Exhibit D

MEMO

TO	Jane Smith, Judy Brown – State Lands Commission Ellen Lirley – California Coastal Commission Benjamin James – California Regional Water Quality Control Board Tamara Spear – California Department of Fish and Game Robert Smith – United States Army Corps of Engineers Brian Mooney – City of Del Mar	**DATE**	October 27, 2008
FROM	Dustin Fuller, Sr. Environmental Planner, 22nd DAA		
PROJECT NAME	Sewer Forcemain Replacement Project		
SUBJECT	Outer Pipe Size Increase (14" – 16")		
CC	File		
Attachments	Revised Site Plans

CITY OF DEL MAR
DEL MAR FAIRGROUNDS
SEWER FORCE MAIN
REPLACEMENT

GRADING, DRAINAGE, EROSION & SEDIMENT CONTROL PLAN FOR
DEL MAR FAIRGROUNDS
FORCE MAIN
PLAN AND PROFILE

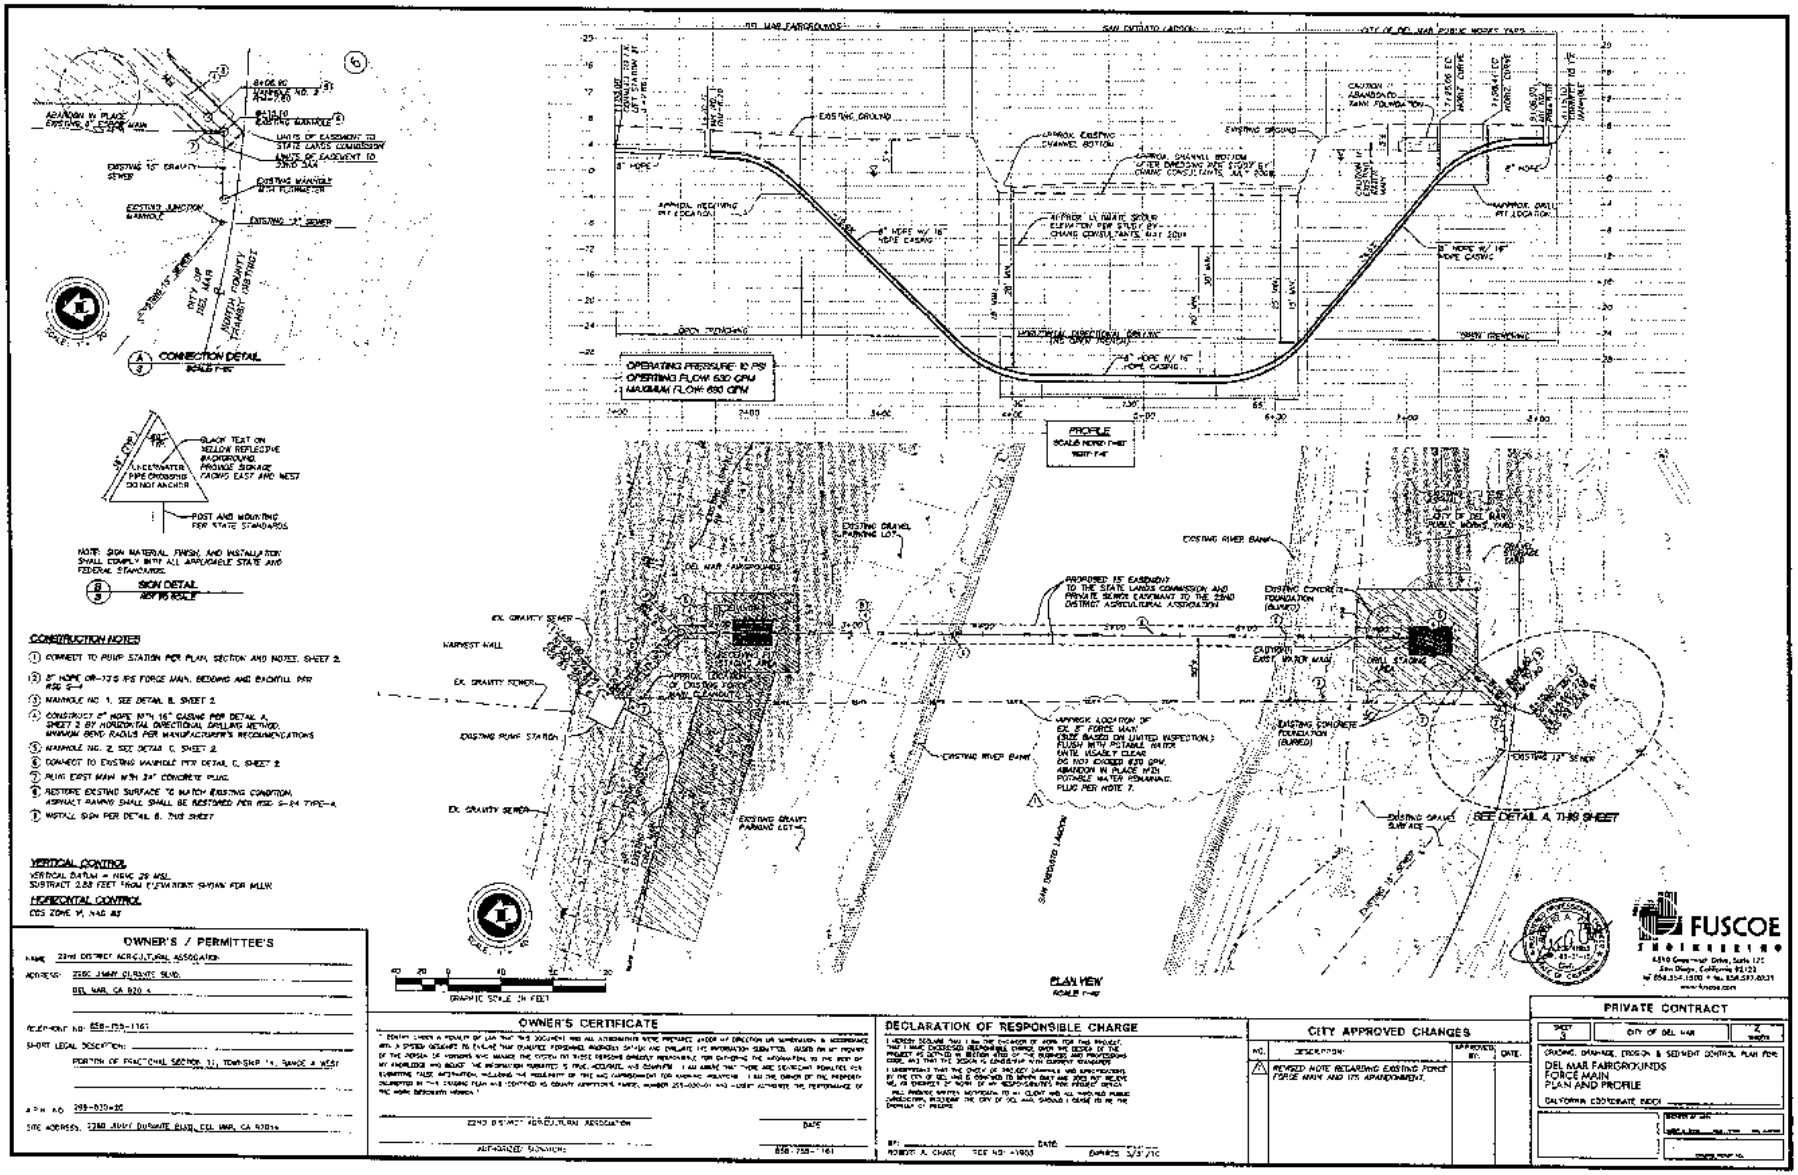
1. CONNECT TO PUMP STATION PER PLAN, SECTION AND NOTES, SHEET 2.
2. 8" HDPE DR-17.0 PE FORCE MAIN, BEDDING AND BACKFILL PER #30 S-1
3. MANHOLE NO. 1, SEE DETAIL B, SHEET 2
4. CONSTRUCT 8" HDPE WITH 16" CASING PER DETAIL A, SHEET 2 BY HORIZONTAL DIRECTIONAL DRILLING METHOD. MINIMUM BEND RADIUS PER MANUFACTURER'S RECOMMENDATIONS
5. MANHOLE NO. 2, SEE DETAIL C, SHEET 2
6. CONNECT TO EXISTING MANHOLE PER DETAIL C, SHEET 2
7. PLUG EAST MAIN WITH 24" CONCRETE PLUG
8. RESTORE EXISTING SURFACE TO MATCH EXISTING CONDITION. ASPHALT PAVING SHALL SHALL BE RESTORED PER #30 S-24 TYPE-A
9. INSTALL SIGN PER DETAIL B, THIS SHEET
